UNITED STATES PATENT AND TRADEMARK OFFICE

APPLICATION NO.	FILING DATE	FIRST NAMED INVENTOR	ATTORNEY DOCKET NO.	CONFIRMATION NO.
10/791,841	03/04/2004	Russell May	3811-012-27	3864

Office Action Summary	Application No.	Applicant(s)	
	10/791,841	MAY ET AL.	
	Examiner	Art Unit	
	Samuel A. Turner	2877

DETAILED ACTION

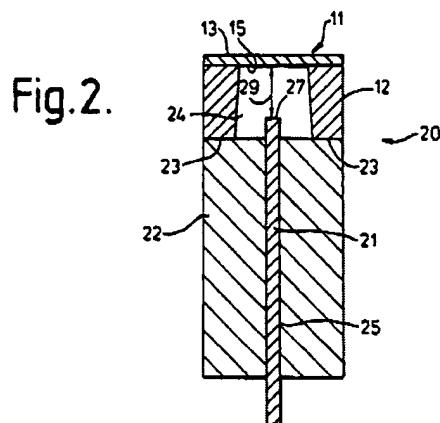
Claims 1, 2, 6, 14-17, and 21 are rejected under 35 U.S.C. 102(b) as being clearly anticipated by Totterdell et al(5,365,789).

With regard to claim 1, Totterdell et al teach a sensor comprising:
a ferrule(22), the ferrule having a bore(25) formed therein;
an optical fiber disposed within the bore(21);
a spacer(12) having a first end and a second end, the first end being attached to an end of the ferrule, the spacer having an opening(24) formed therein; and
a diaphragm(15) attached to the second end of the spacer such that it extends over the opening in the spacer, the diaphragm having an inside reflecting surface facing an end of the optical fiber, the end of the optical fiber and the inside reflecting surface of the diaphragm being spaced apart to form a Fabry-Perot cavity.

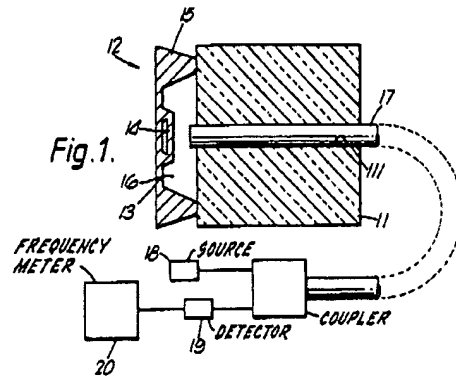
Claims 42, 46-48, 52, and 53 are rejected under 35 U.S.C. 102(b) as being clearly anticipated by Greenwood et al(4,884,450).

With regard to claim 42, Greenwood et al teach a sensor comprising:

a ferrule(11) formed of a single crystal material(column 2, lines 12-13), the ferrule having a bore(111) formed therein;

a diaphragm(13,15) attached to the ferrule, the diaphragm having a pit formed in a surface of the diaphragm facing the ferrule, the pit having a wider diameter than a diameter of the bore, the pit having an inside reflecting surface facing the ferrule; and

a fiber(17) disposed within the bore, an end of the optical fiber and the inside reflecting surface of the pit on the diaphragm being spaced apart to form a Fabry-Perot cavity.

FIG. 4

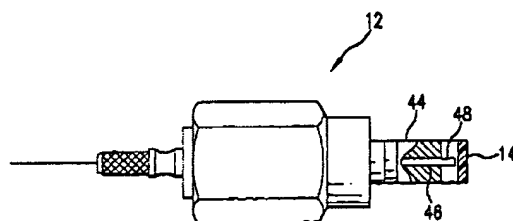
With regard to claim 30, Balachandran et al teach a sensor comprising:
a ferrule having a bore and pit formed therein, the pit having a wider diameter than a diameter of the bore, the bore intersecting the pit(44);
a diaphragm(44); and
a fiber(46) disposed within the bore, an end of the optical fiber and the inside reflecting surface of the diaphragm being spaced apart to form a Fabry-Perot cavity.

Note that Balachandran et al is silent on the structure of the ferrule and fiber, and teaches a diaphragm of Mylar.

With regard to claims 30, 34, 35, 36, 40, and 41; it would have been obvious to one of ordinary skill in the art at the time the invention was made to form any or all of the elements of the sensor out of a single crystal material depending on the environment and the need to match coefficients of expansion.
